BUILDING PERMIT

Job Address <i>100 W. BERSEN DR.</i>	Building Type: Residential - Commercial
Description of Work <i>AS PORTION OF KITCHEN REMODEL - REMOVE 8' SECTION OF NON-LOAD BEARING WALL. ADDING 11' LONG, 2'X10' I-STRUDER REMOVING PROP CEILING (SEE ATTACHED)</i>	
Estimated Cost of Project \$ <i>SEE LABEL, ~\$450.00 MATERIALS</i>

PLAN REVIEW

Letter of Conditional Approval

PARTIAL 1ST FLOOR DEMO PLAN
2ND FLR FRAMING

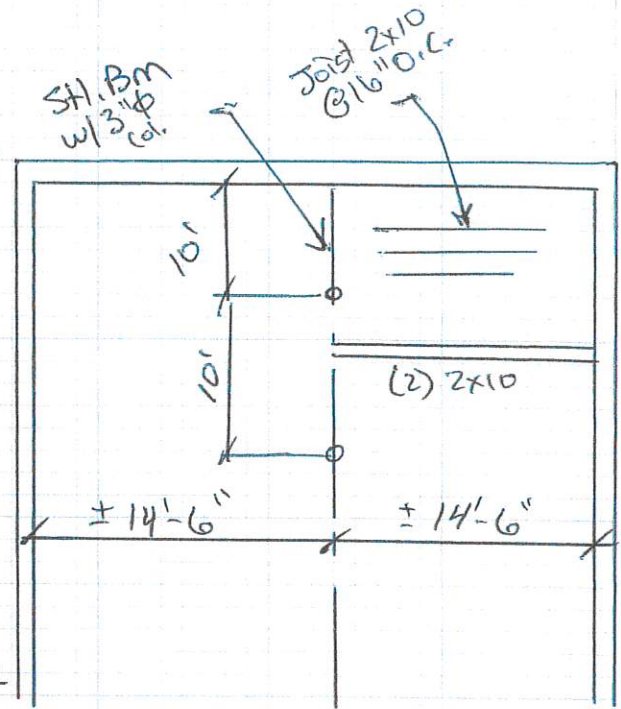
New 17'-0" LG HEADER
SEE ATTACHED CALC
USE: (2) 2x10's

CONDITIONALLY APPROVED
CONTINGENT UPON COMPLIANCE WITH ALL CODES
VILLAGE OF FOX POINT
